ORIGINATION FORM

Proposed Revisions to a Standard Plans Index
(Please provide all information — Incomplete forms will be returned)

Index Number: 715-001
Sheet Number (s): 1
Index Title: Conventional Lighting

METAL POLE DETAIL

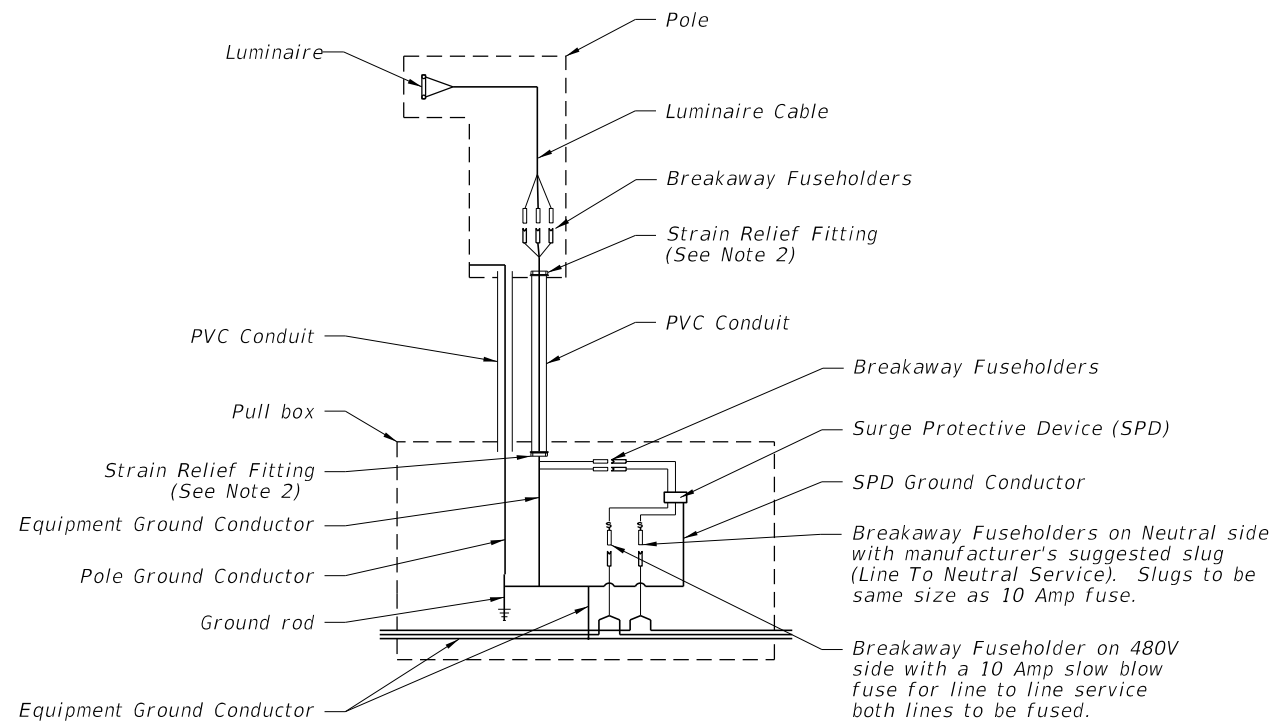
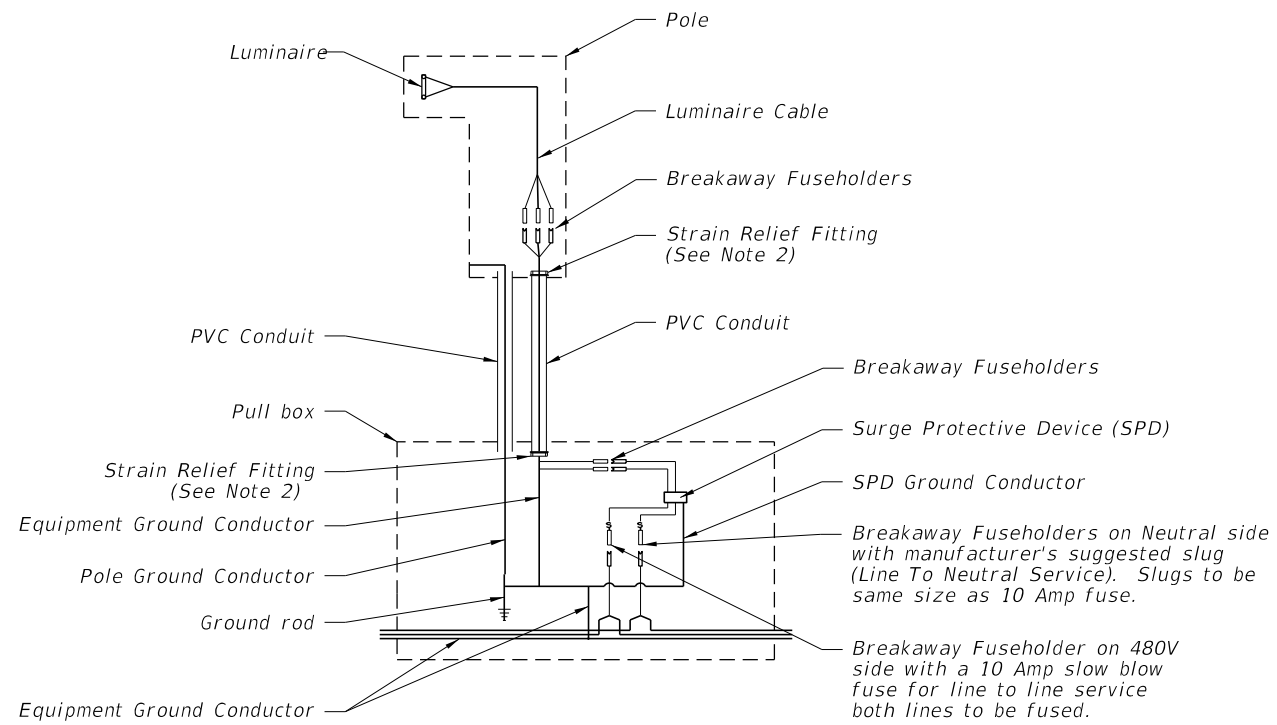
Sheet 1: Deleted the "Access Panel" drawing and added a "Pole Base" callout on the 'Metal Pole Wiring Detail'.
Added the "Access Door" drawing and a "Pole Base" callout on the 'Metal Pole Detail'.

METAL POLE WIRING DETAIL

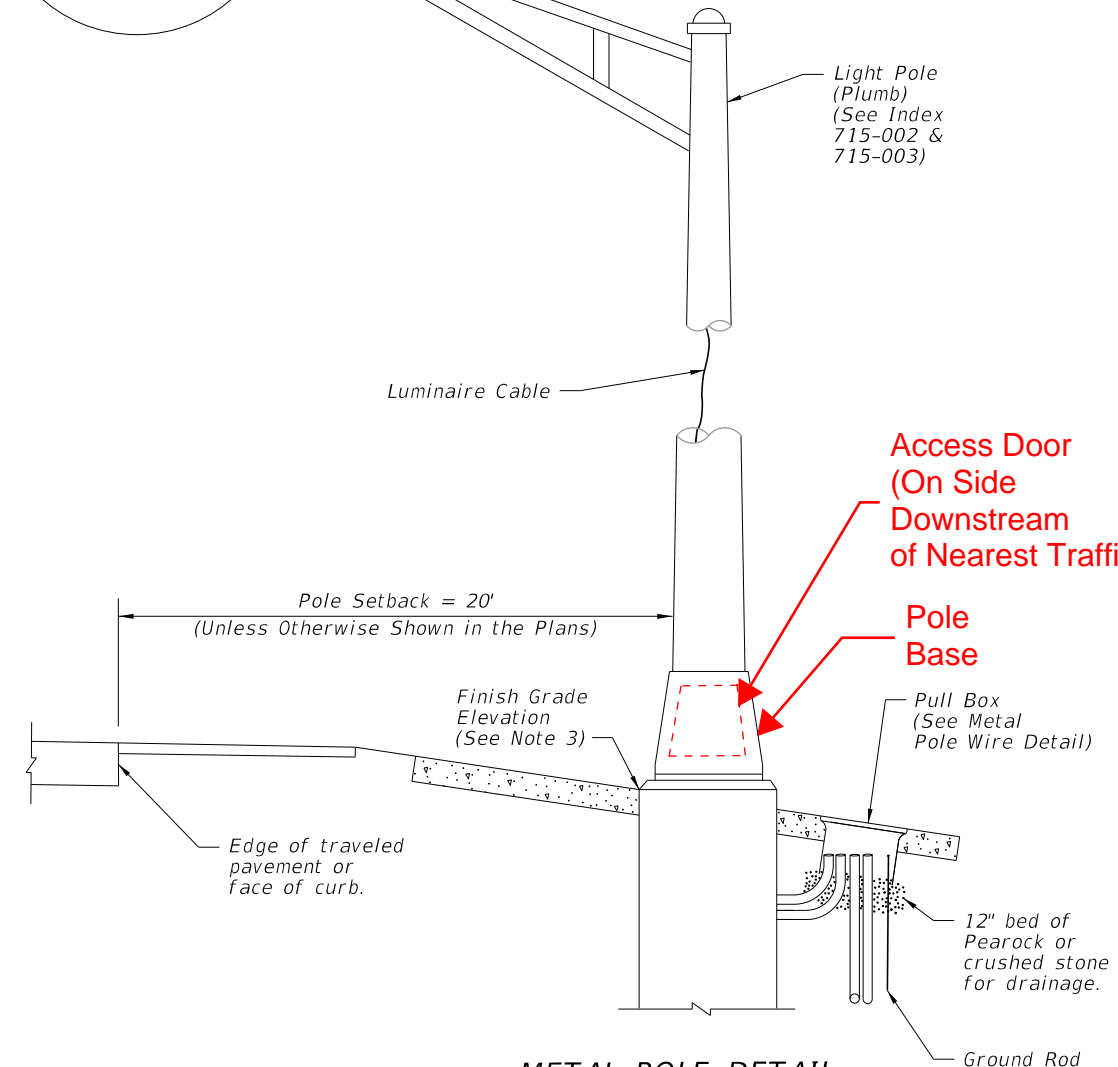
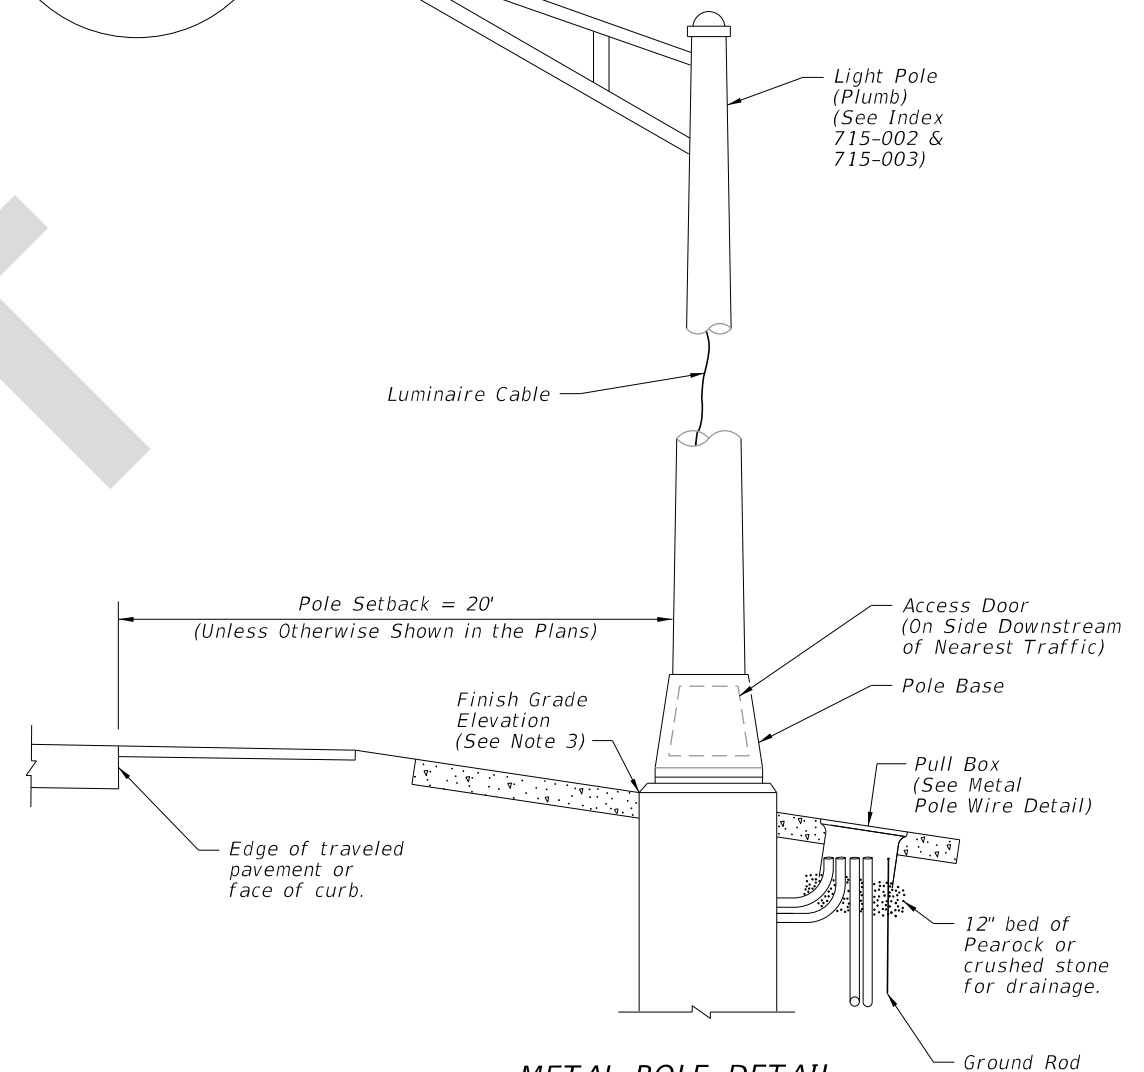
The details were revised to locate the Access Door on the downstream side of the Pole Base for better consistency with Standard Specifications 715-13.1. The downstream side is relative to the nearest traffic movement.
